RECALL CAMPAIGN

**REF. NO. 145
TESTAROSSA PASSIVE RESTRAINT
SYSTEM**

MARCH 1989

RECALL CAMPAIGN NO. 145**INTRODUCTION - TESTAROSSA PASSIVE RESTRAINT SYSTEM**

FIGURE 1

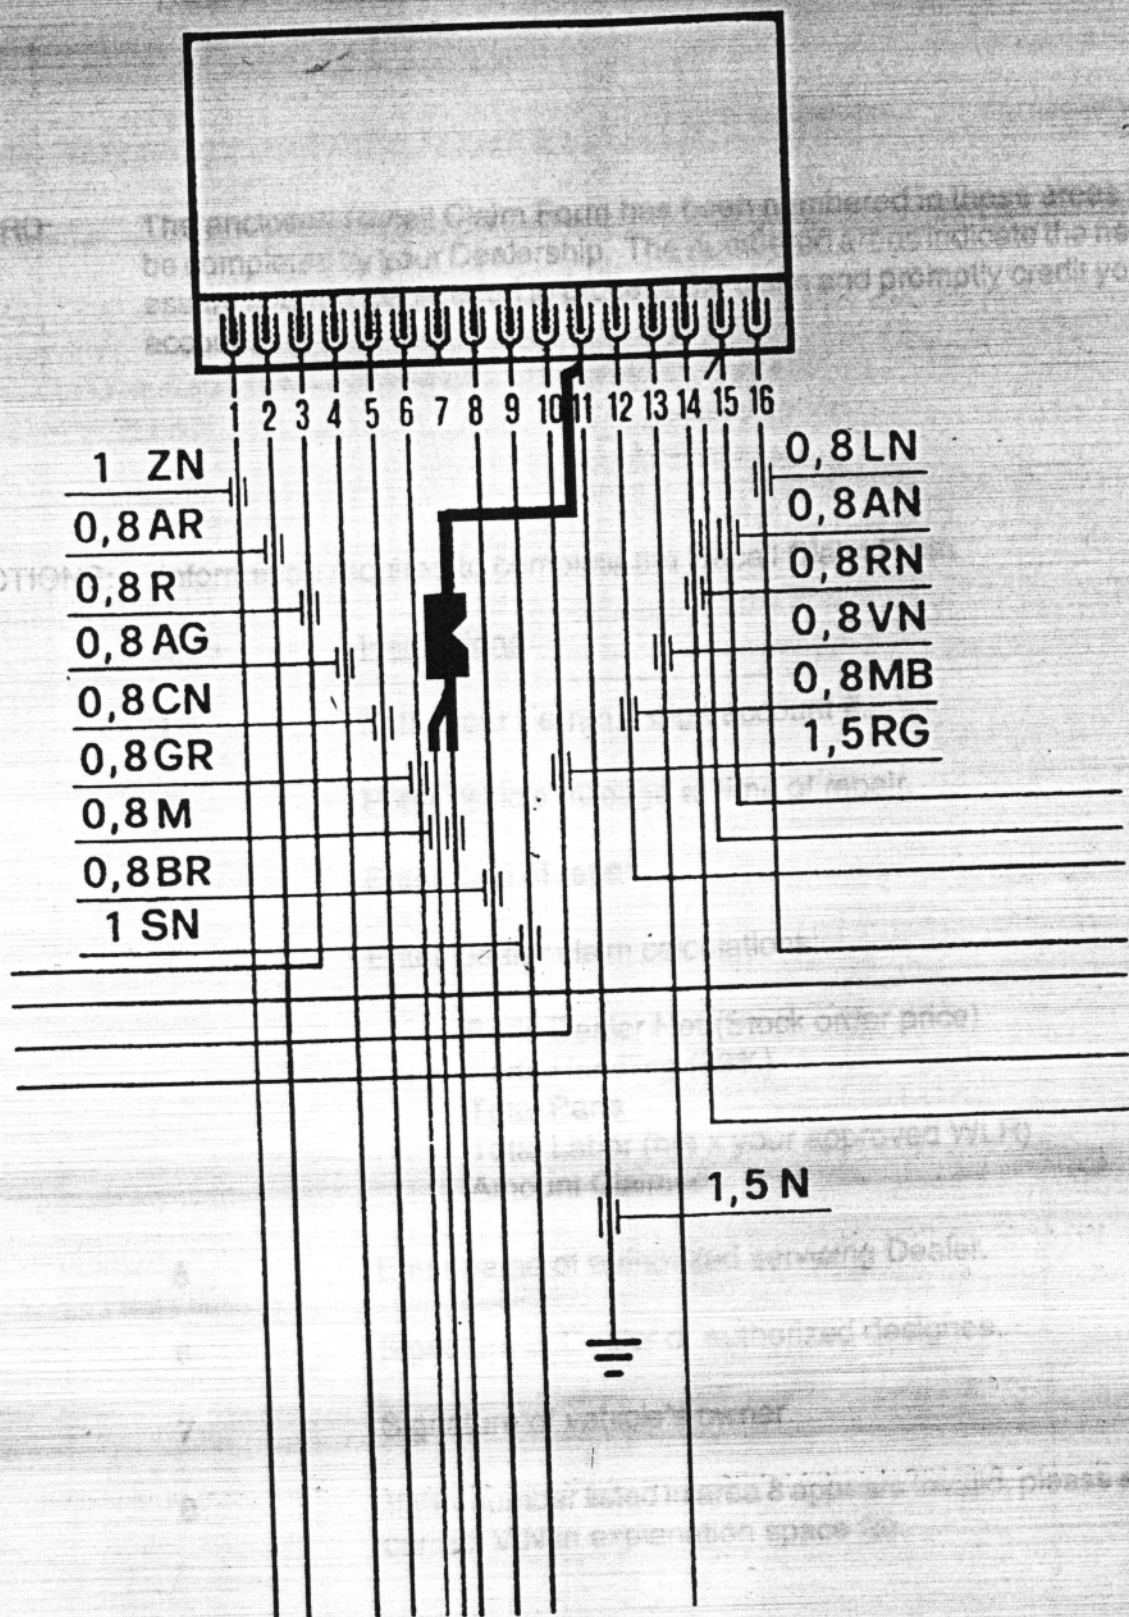
THE MODIFIED ECU CANNOT BE FITTED ON VEHICLES WITH C.N. LOWER THAN 72631 WITHOUT CERTAIN CHANGES TO THE ELECTRICAL WIRING GOING TO THE PASSIVE SEAT BELT ECU'S AS DESCRIBED BELOW. THE MODIFIED ECU P.N. 4561 IS THE ONLY TYPE NOW AVAILABLE AS A SPARE PART AND CAN ONLY BE FITTED TO EARLIER VEHICLES (C.N. 72631) IN PAIRS. BOTH LEFT AND RIGHT SIDE MUST BE REPLACED TOGETHER, FAILURE TO DO SO WILL DAMAGE NEW ECU'S.

When fitting the late type Passive Safety Belt ECU's P.N. 4561 to a vehicle fitted with the early type ECU P.N. 61555000, (C.N. lower than 72631) the electrical wiring must be modified in the following manner:

1. Turn off Battery Master Switch.
2. Remove electrical plugs from both left and right ECU's located in center console.
3. Remove the 2 wires going to terminal No. 7 of the electrical plug and join together with wire going to terminal No. 11 (Refer to Figure 1).
4. Perform the above operation for the other ECU.
5. Replace ECU's with new type and reconnect electrical plugs.
6. Switch on Battery Master Switch.
7. Check operation of Passive Seat Belt System.

SEAT BELTS

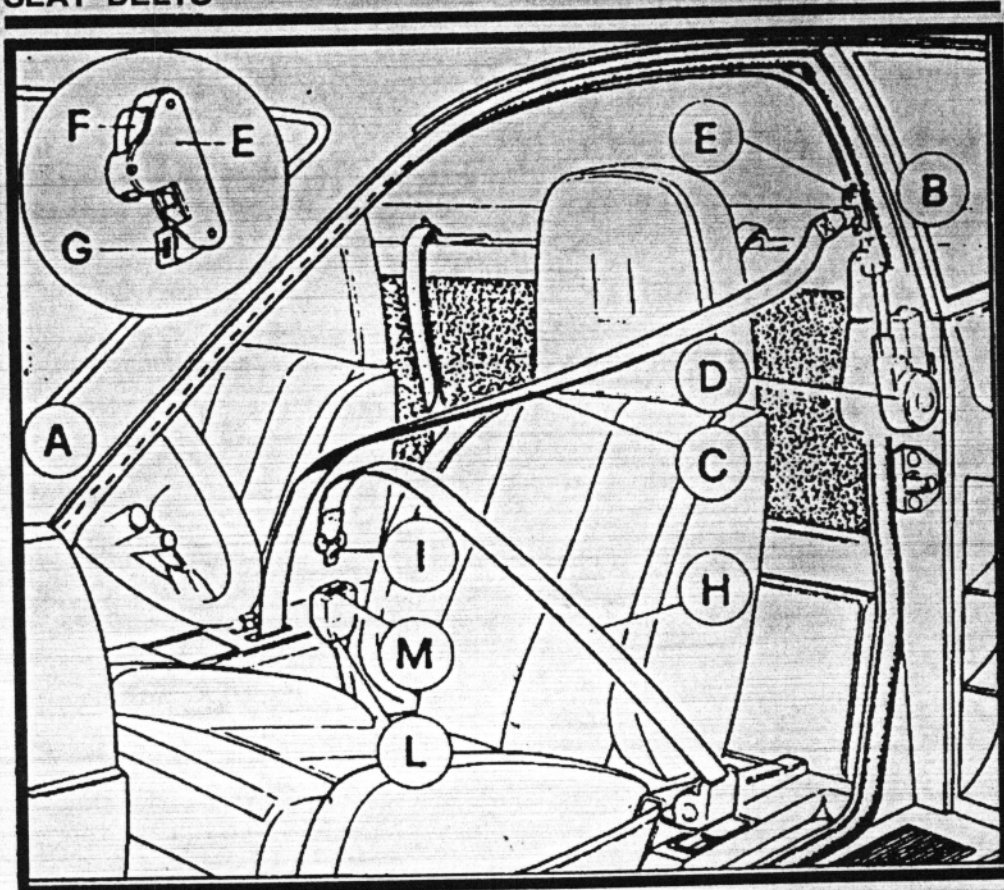
As a temporary measure until repairs are effectuated, the Safety Belt should be positioned manually if the automatic Passive Restraint System does not operate, (please refer to the attached instructions or Page 37 of the Owner's Manual).

In case of failure of the automatic mechanism, the belt can be positioned and fastened manually. For this purpose push the black button (F) in order to disengage the guide and manually slide the guide with the belt connected, along the track from A to B (or vice-versa). In this case of failure of the system, the seat belt warning light remains activated.
